REQUEST

Current Zoning: NC (neighborhood center)
Proposed Zoning: MUDD-O PED (mixed use development, optional, Pedestrian Overlay)

Approximately 0.94 acres located at the southeast intersection of Commonwealth Avenue and The Plaza, north of East Independence Boulevard.

The petition proposes to allow for the redevelopment of a parcel utilized as surface parking with multi-family residential and commercial uses. Golden Triangle #7 – Commonwealth, LLC, Levine Properties, Inc. Levine Properties, Inc. Brittany Lins and Collin Brown, Alexander Ricks, PLLC Meeting is required and has been held. Report available online. Number of people attending the Community Meeting: 26

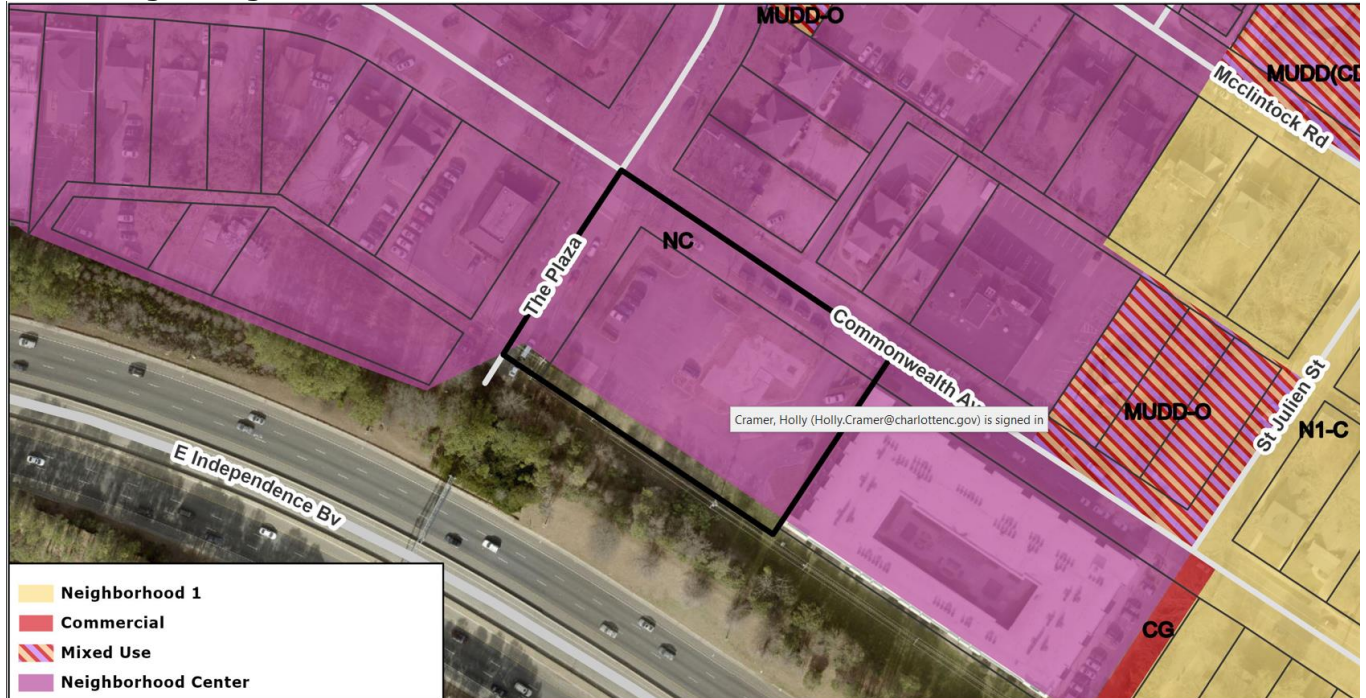
1. Show required right-of-way trees.

3. ~~Reduce the maximum height to provide contextual sensitivity to the surrounding building forms.~~ **Addressed**
4. Revise note 7 under the Design Guidelines to commit to community benefits to achieve building height above 80'. Commit to specific community benefits.

-
- ~~5. Identify building envelopes(s) rather than one development area.~~ **Rescinded**
 6. Remove optional provision allowing for a drive-through.
-
